Peach Bottom Atomic Power Station, Units 2 and 3  
Renewed Facility Operating License Nos. DPR-44 and DPR-56  
Docket Nos. 50-277 and 50-278

Subject: License Amendment Request – Application of Alternative Source Term

FIGURE 5.2.16

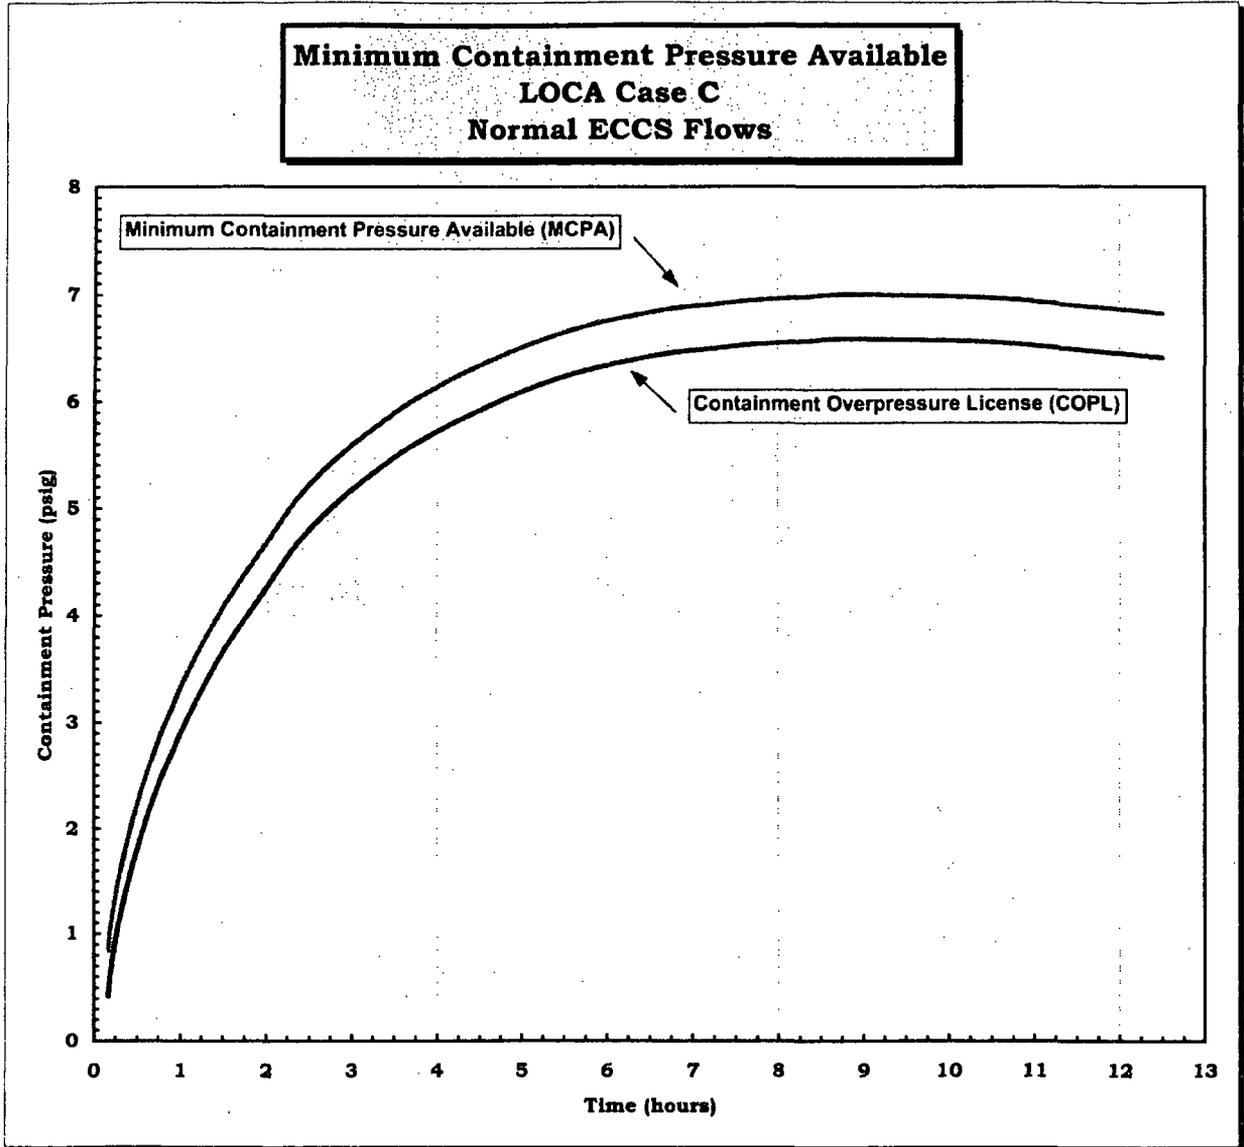
There is an additional proposed change to the UFSAR. It is proposed to revise UFSAR Section 5.2.4.3.2, "Minimum Containment Pressure Available," to reflect the impact of AST assumptions. Portions of the text and Figure 5.2.16, "Minimum Containment Pressure Available and Containment Overpressure License," were previously approved by the NRC in a Safety Evaluation dated August 14, 2000 (Reference 7.22). Refer to Attachment 6 of this submittal for additional information concerning the proposed UFSAR changes.

The proposed change to the UFSAR revises the Containment Overpressure License (COPL) described in UFSAR Figure 5.2.16 to increase the COPL; however,

adequate margin is maintained between the revised Minimum Containment Pressure Available (MCPA) and the proposed COPL.

The PBAPS, Units 2 and 3, licensing basis has previously included reliance on containment overpressure for the residual heat removal (RHR) and the core spray (CS) pumps following a postulated design basis loss of coolant accident (LOCA). An analysis is maintained that conservatively estimates the Minimum Containment Pressure Available (MCPA) following a postulated design basis LOCA. A brief discussion of this analysis is included in PBAPS UFSAR Section 5.2.4.3.2. Although the MCPA analysis is conservative, a change to the PBAPS Operating License was approved by the NRC (Reference 7.22) to define a Containment Overpressure License (COPL) less than the evaluated MCPA for the design basis LOCA. Both the MCPA for the design basis LOCA and the COPL are shown in PBAPS UFSAR Figure 5.2.16. The PBAPS OL permits credit for containment overpressure for any design basis event up to the MCPA for that event, but not greater than the COPL. Exelon has included a revision to PBAPS UFSAR Section 5.2.4.3.2 and Figure 5.2.16 in this License Amendment Request. The revised Figure 5.2.16 shows the revised MCPA and the proposed new COPL. Text

Because of the conservative assumptions and input values used in the MCPA analysis, use of the MCPA in NPSH analyses is conservative. However, the PBAPS licensing basis grants containment overpressure credit as follows:

Time	COPL
0 to 10 minutes	2.25 psig
10 minutes to 12.5 hours	COPL of Figure 5.2.16
12.5 to 78 hours	Exponentially decreasing from Figure 5.2.16 to zero

For any design basis event, the maximum containment overpressure credit allowed is therefore the MCPA associated with that event, but not greater than the containment overpressure credit given in the table above.
